SERVICE BULLETIN

No. 643A

Piper Aircraft Corporation

Subject: Oil and Manifold Pressure Tubes Inspection

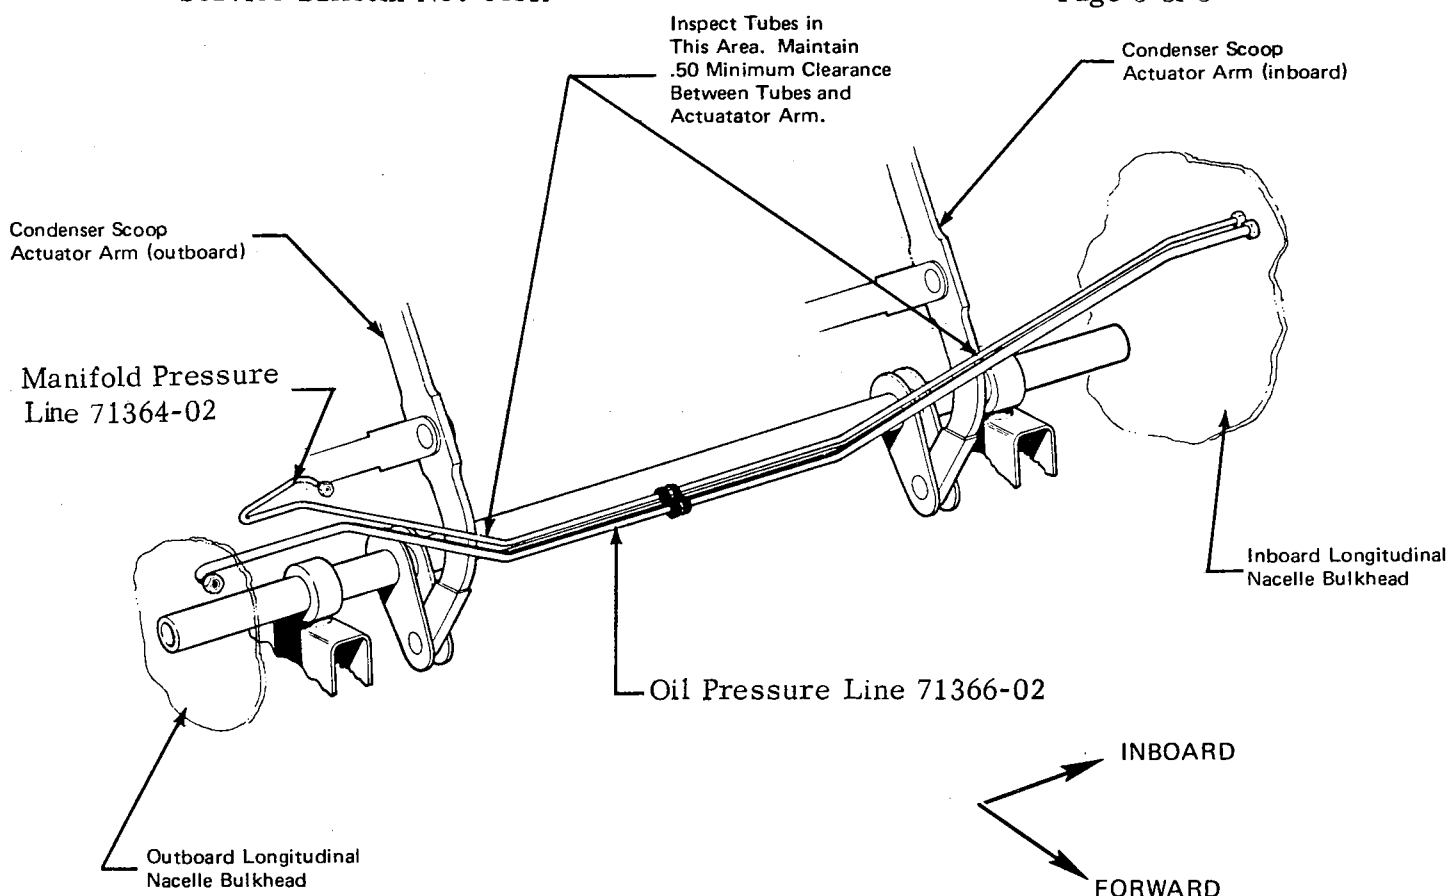
1. Remove the top, inboard and outboard access panels from the right engine nacelle to gain access to the oil pressure and manifold pressure tubes.
2. Inspect the oil pressure and manifold pressure tubes for possible chafing or interference with the condenser scoop actuator arms as shown.

3. If the oil pressure and/or manifold pressure tubes are not chafed, proceed to Step 5.
4. If the oil pressure and/or manifold pressure tubes are chafed, at either inboard or outboard actuator arm, tubes must be replaced with new tubes as shown on sketch above.

5. Operate the condenser scoop to the full open position and inspect for proper clearance between the actuator arms and oil pressure, manifold pressure tubes as shown above.

- a. If clearance between actuator arms and tubes is .50 or larger, proceed to Step 6.
 - b. If clearance between actuator arms and tubes is not .50, carefully reposition tubes to gain .50 minimum clearance.

6. Operate condenser scoop to insure .50 minimum clearance, between tubes and actuator arms, during complete cycle.
7. Reinstall access panels removed for this inspection/replacement.
